Summary of Modifications since Validation

Project Pavilion- Riverfront Park

Project No. 111-17036-02F
Meeting Date April 2, 2018
In Attendance Executive Team
Design-Build Team

SCREEN WALL

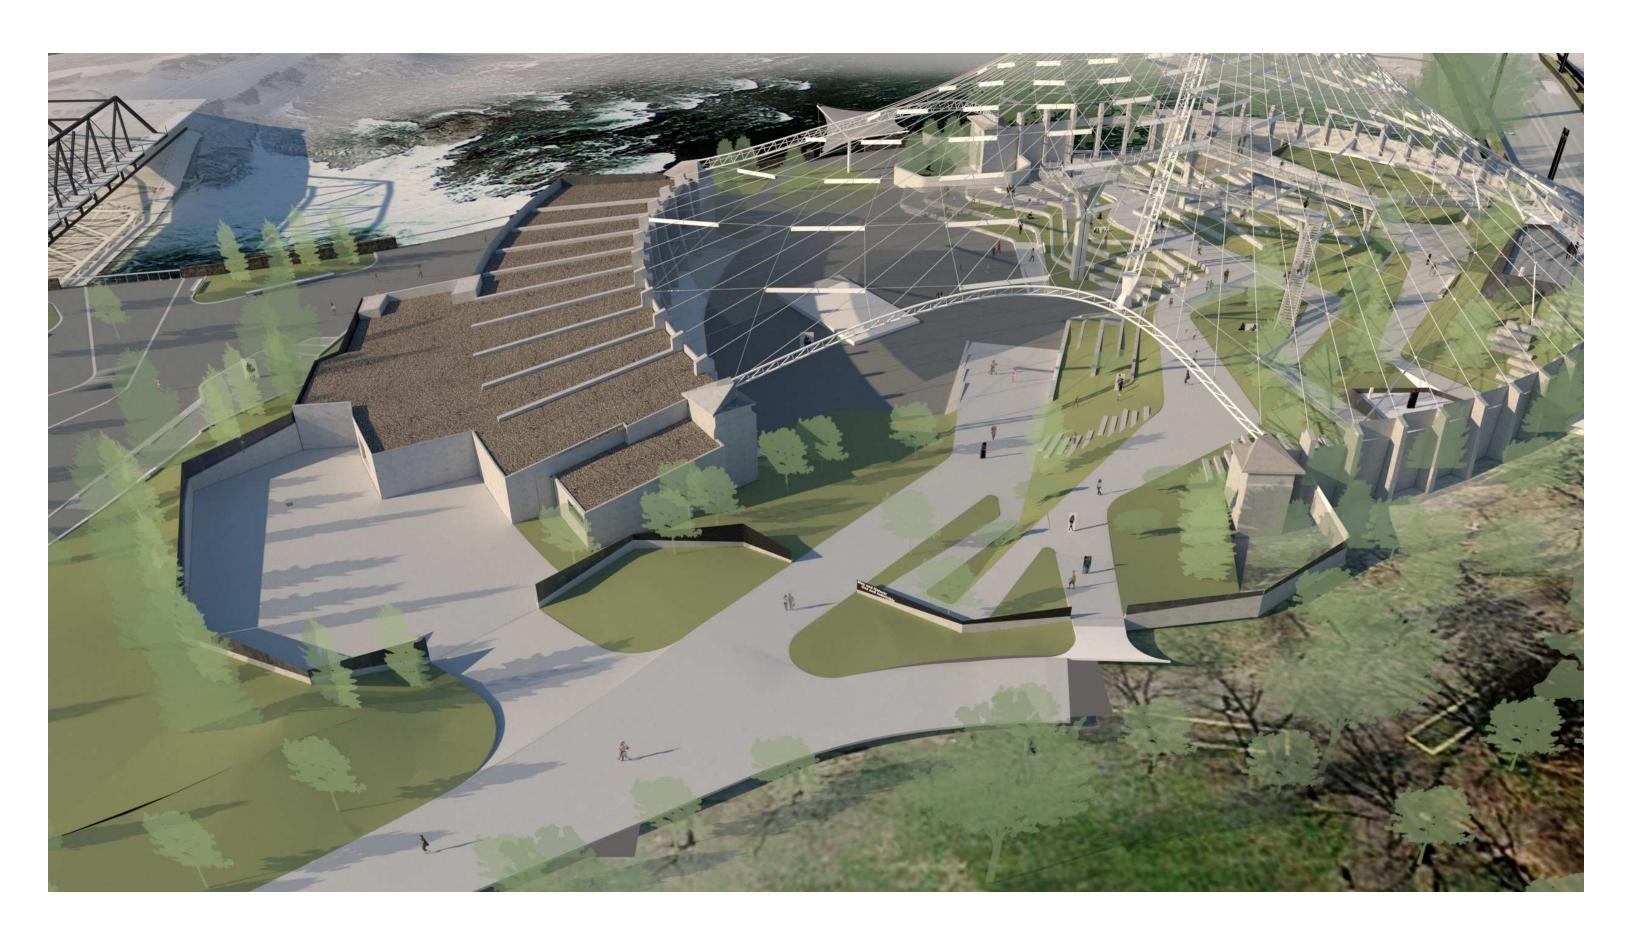
- Development of paving and landscape areas
- Green Roof alternate not accepted
- Development of service yard screen wall and perimeter fencing
- Informal stage and stairs added then removed
- Allowance for 150 lineal feet of new railing at river's edge

ILLUMINATION BLADES

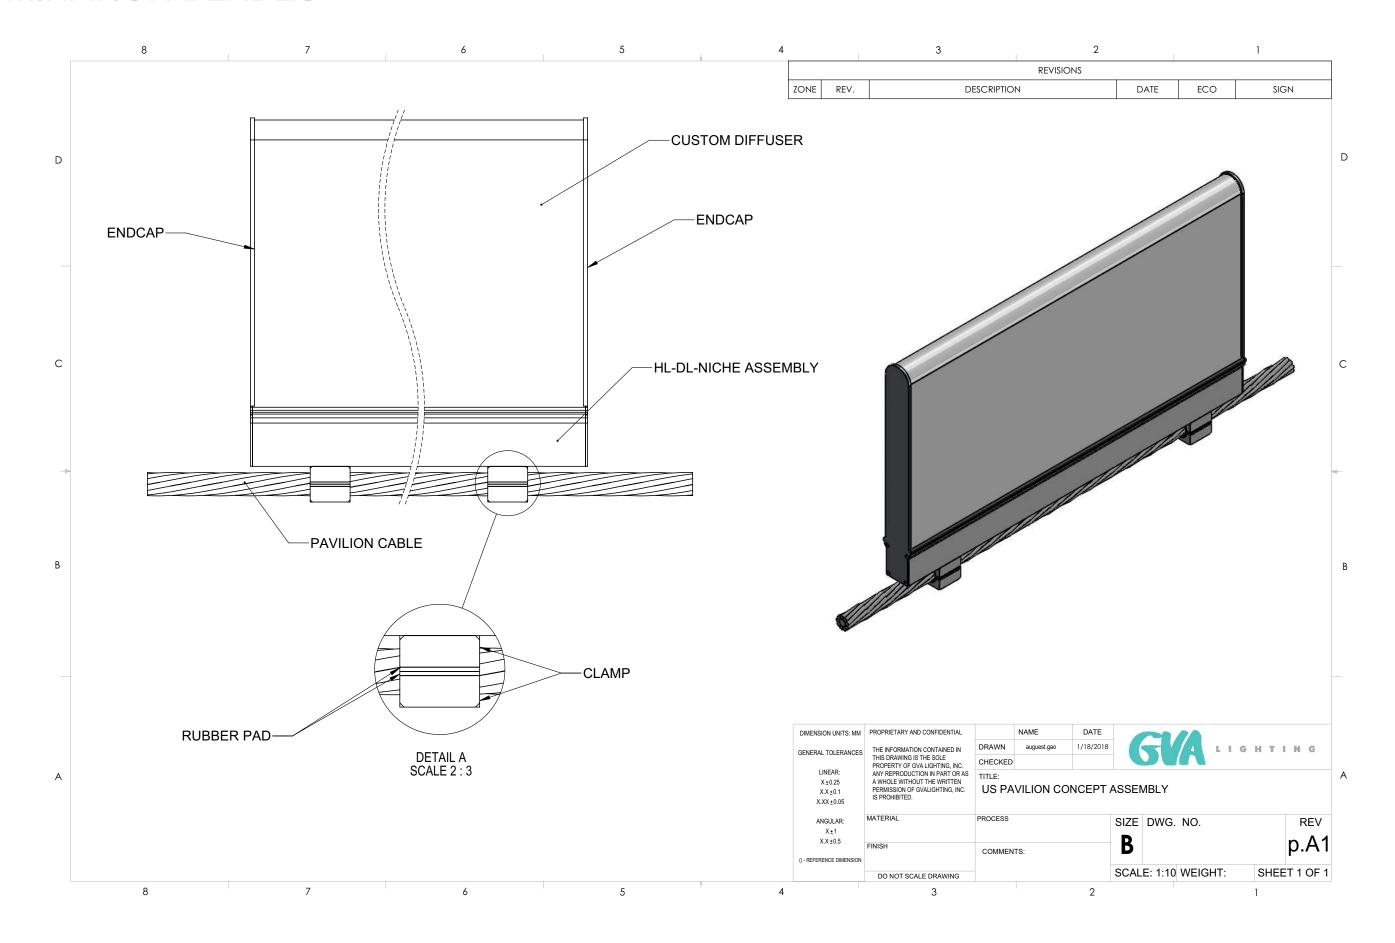
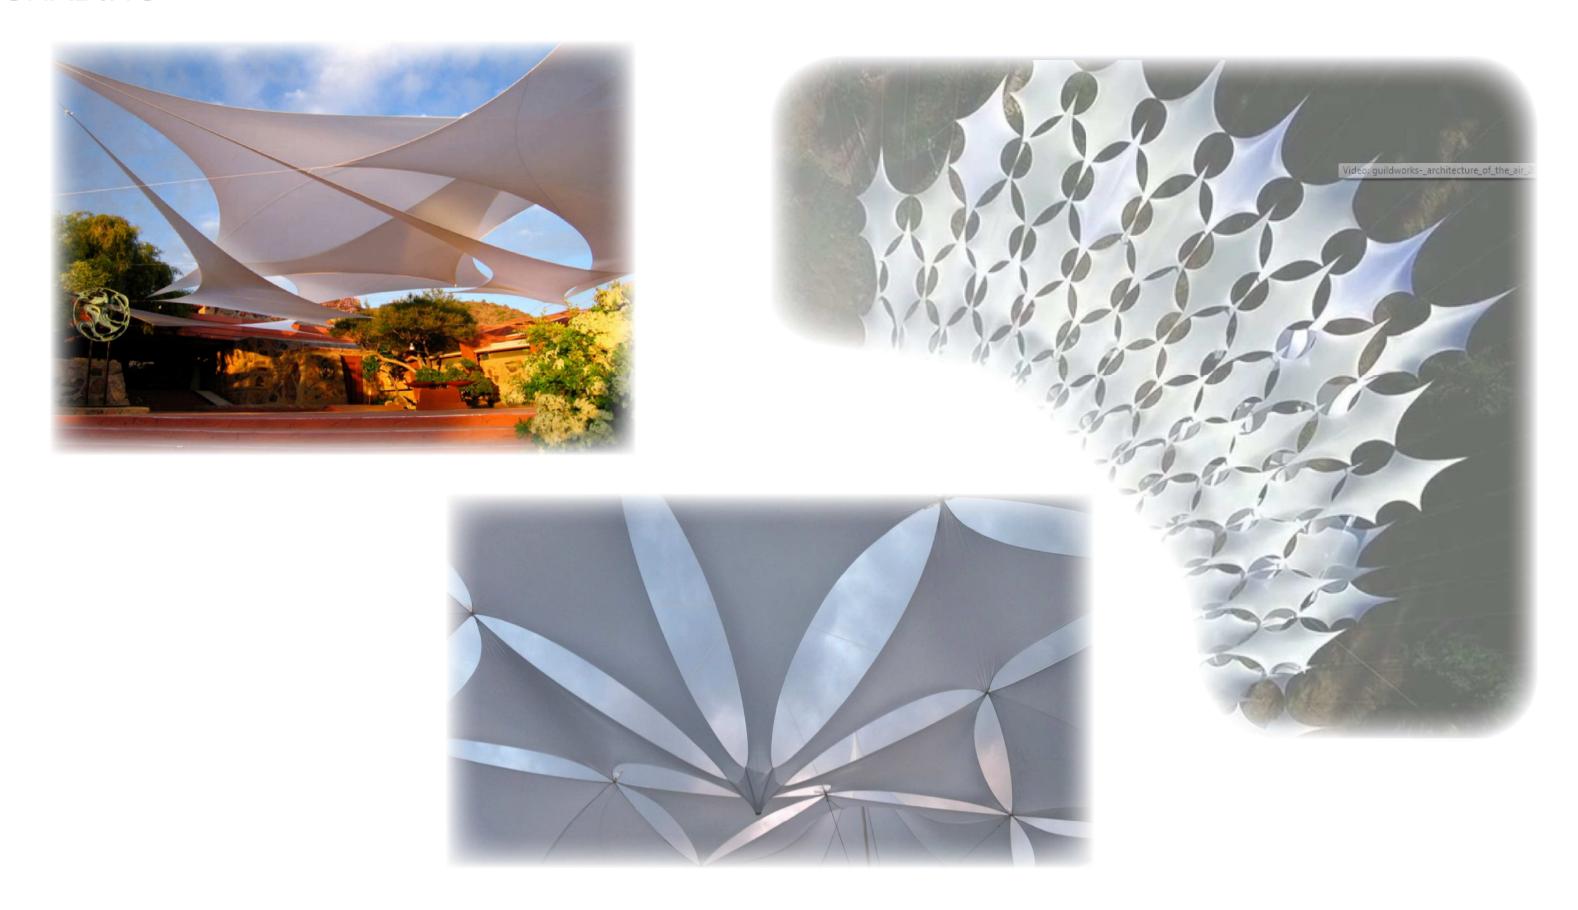
- Evolution of concept
 - custom fixture
 - o manufacturer's fixture with diffuser and remote drivers
 - o manufacturer's fixture with blade and remote drivers

Option 1 - Elevated Experience

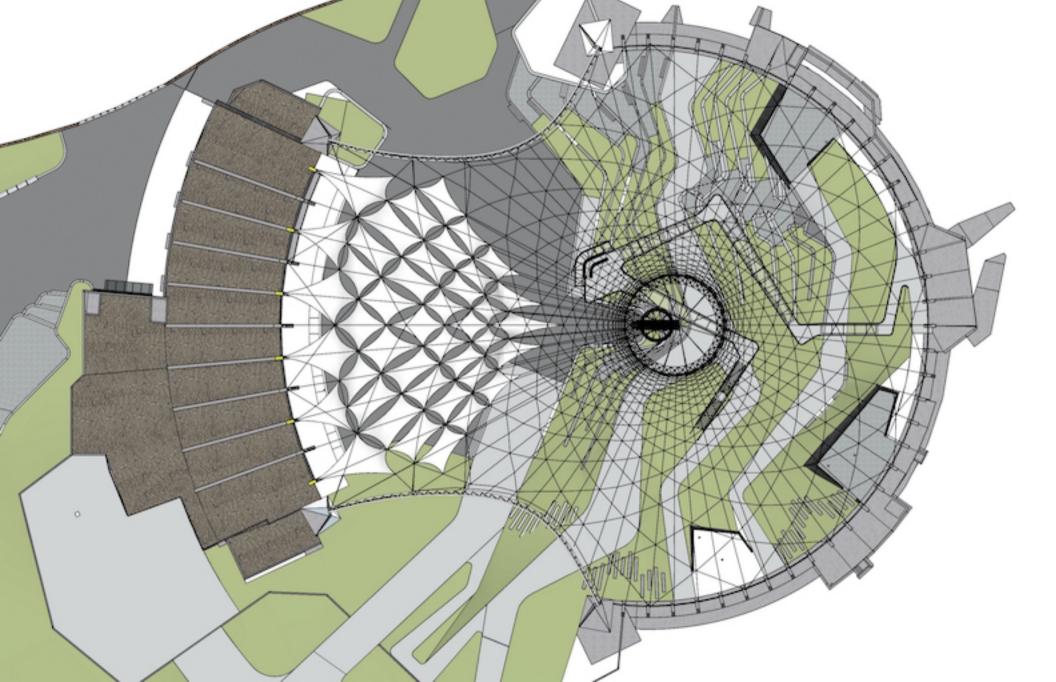
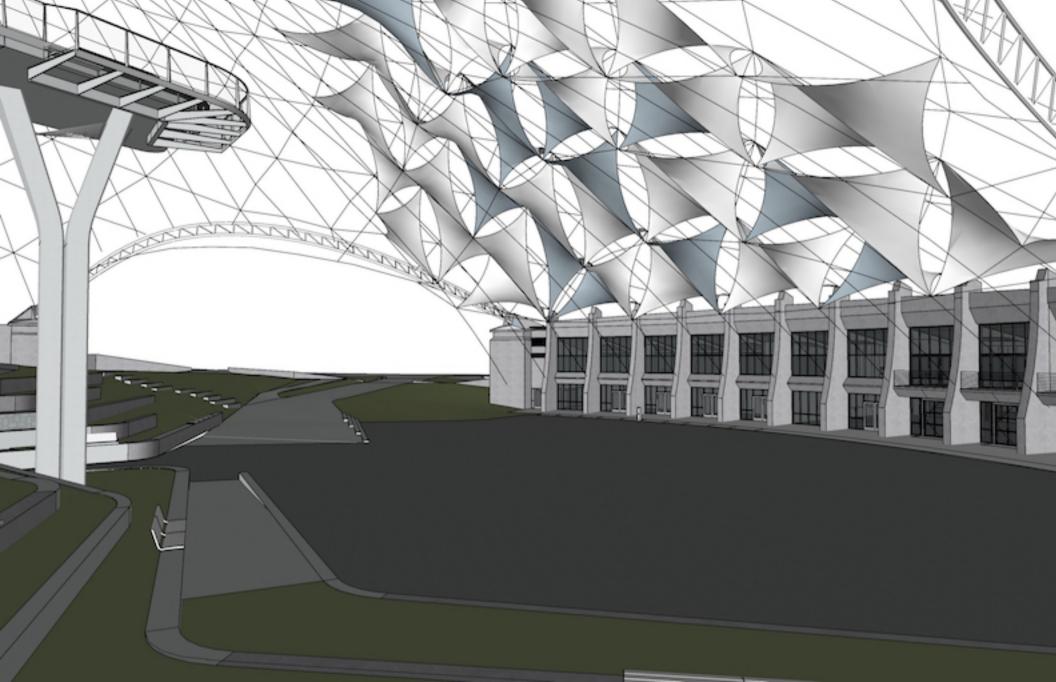
- Concept developing with Guildworks
 - o Separate cables from west building to elevated experience
 - o Existing cables and new lower cables from west building to new mast ring and new back span cables
 - o Shade panels and steel rods weaving through existing cables

Cables extend out from column underneath platform
